ADDENDUM NO. 2

PROJECT NAME: Life Sciences Annex – North and East Wing Renovation
UNL PROJECT NUMBER: A090P025 & A090P026

DATE OF ISSUANCE: February 9, 2012
DATE OF BID OPENING: Thursday, February 16, 2012 @ 2:00 p.m. CDT

Addendum #2
 Supplemental Drawing: SDM-001
 Revision of Sheet: M2.01
 Date: 02/08/12

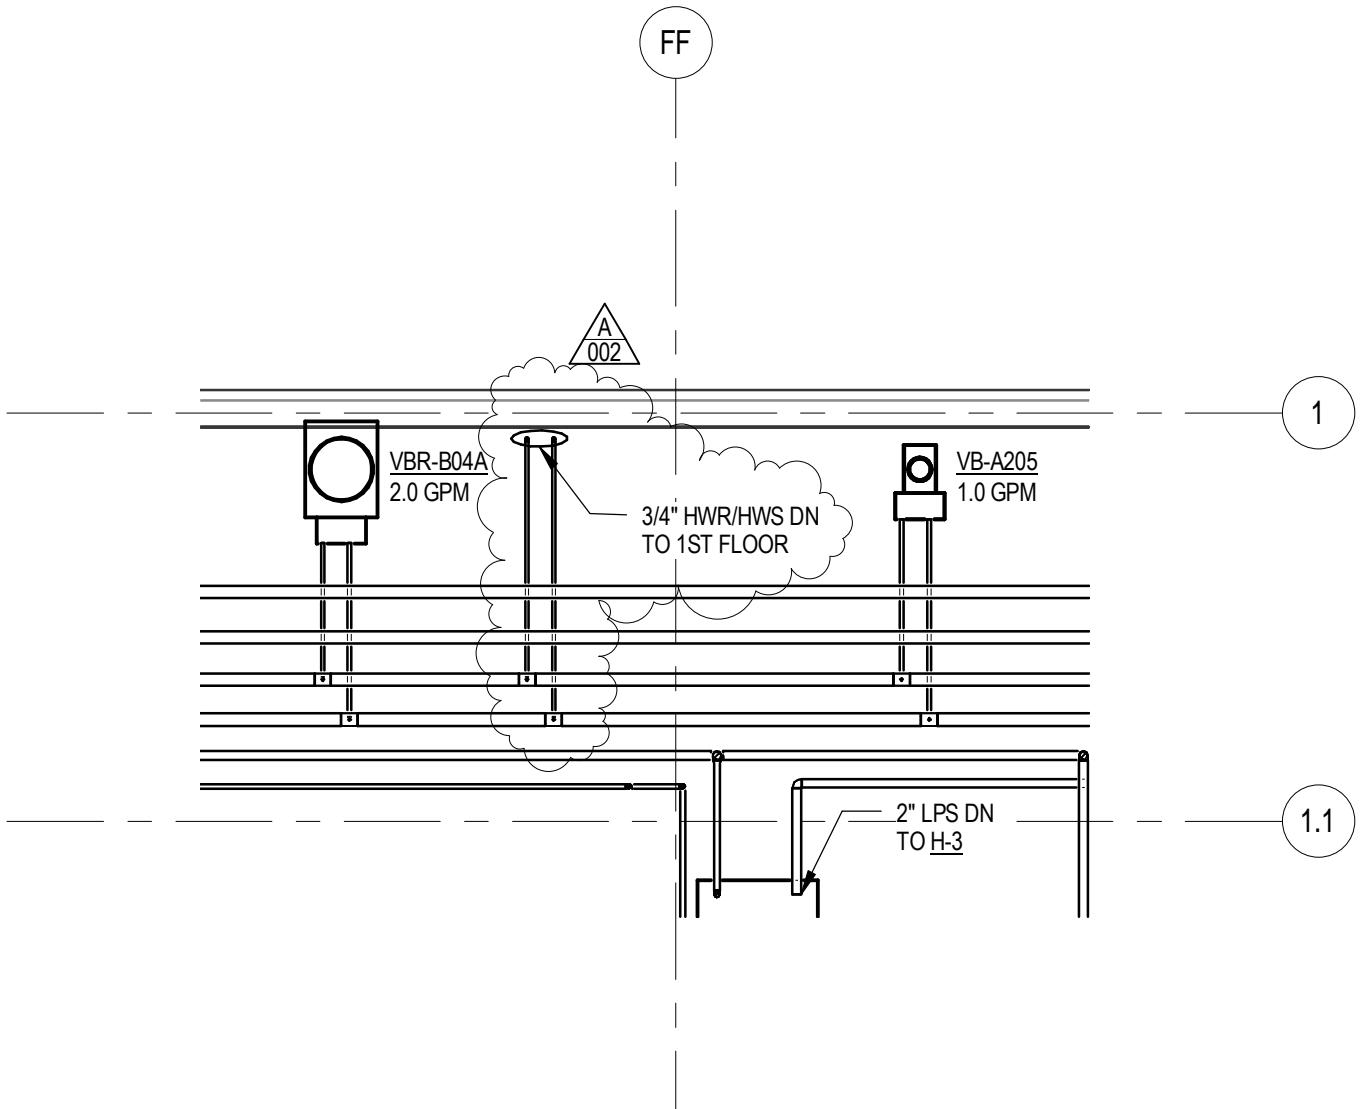
See attached supplemental drawings for mechanical work related to adding cabinet unit heater CUH-3 to Vestibule A15C and cabinet unit heater CUH-4 to Vestibule B02. Add the following to the Cabinet Unit Heater Schedule on sheet M5.01
